REVISED ABUTMENT #2 PLAN
SCALE: 1:50

RIPTON FH 010-1(42)
VTRANS - SEPT. 9, 2010
BY S.FARNSWORTH

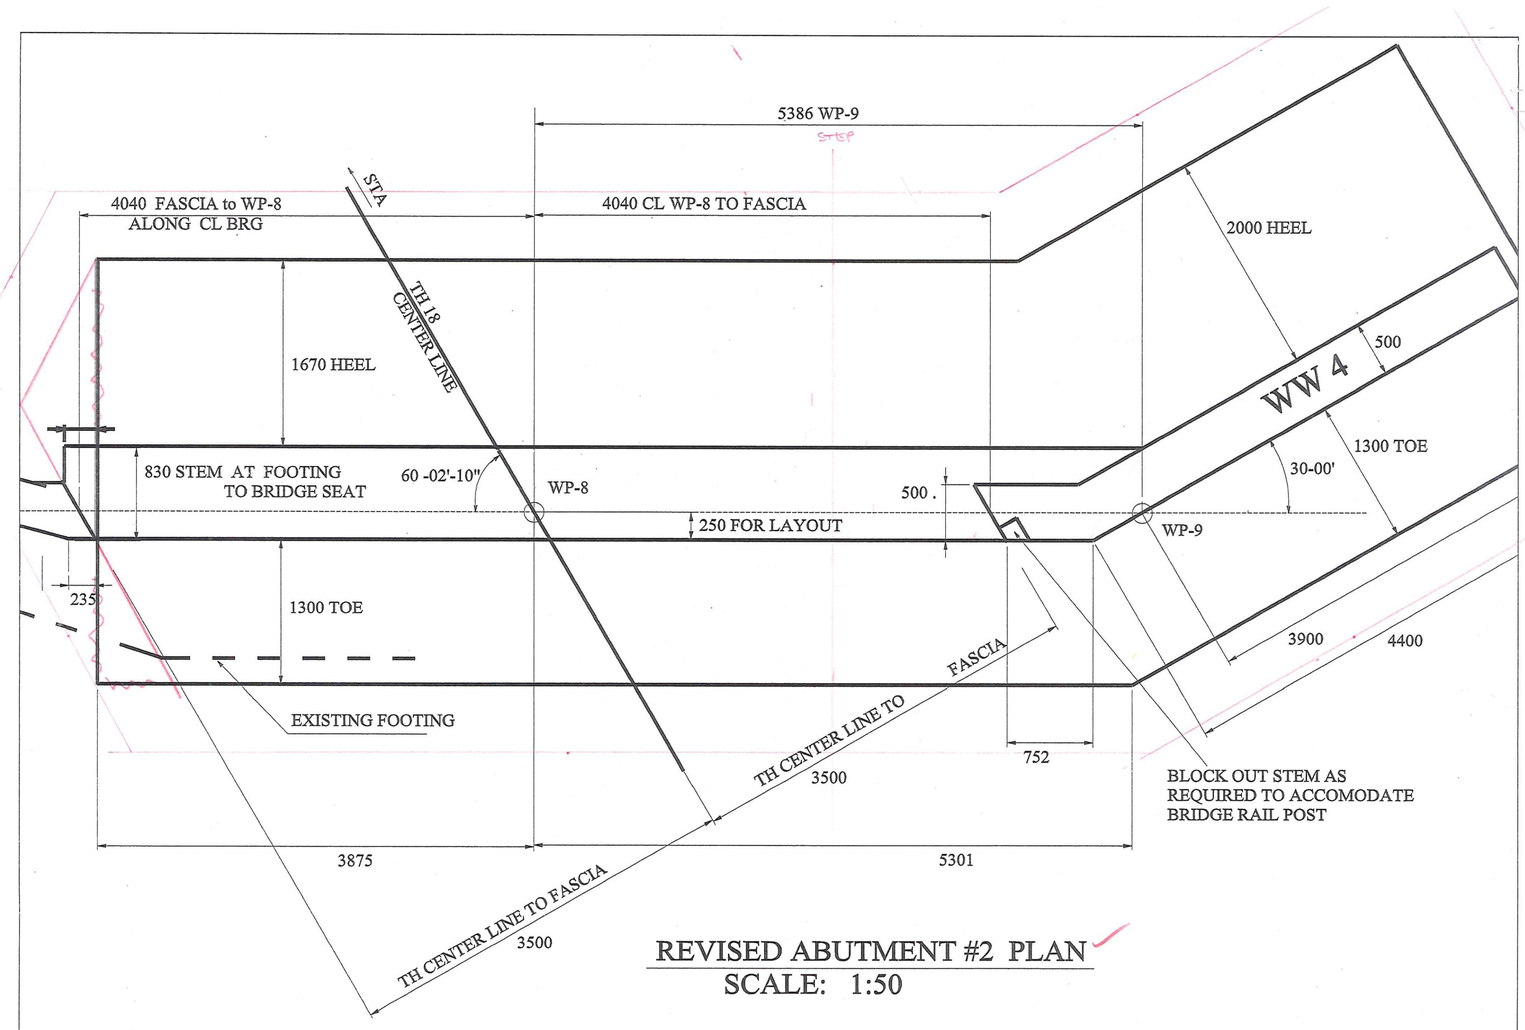
NOTES: 1. THE WORKING POINTS (WP) LAYOUT HAVE NOT CHANGED. WW #4 IS IN THE SAME LOACTION.

2. THERE HAVE BEEN NO CHANGES TO WINGWALL #4.

3. RETAIN WINGWALL #3. DEWATER AND PUMP CONCRETE, CLASS "C" UNDER FOOTING.
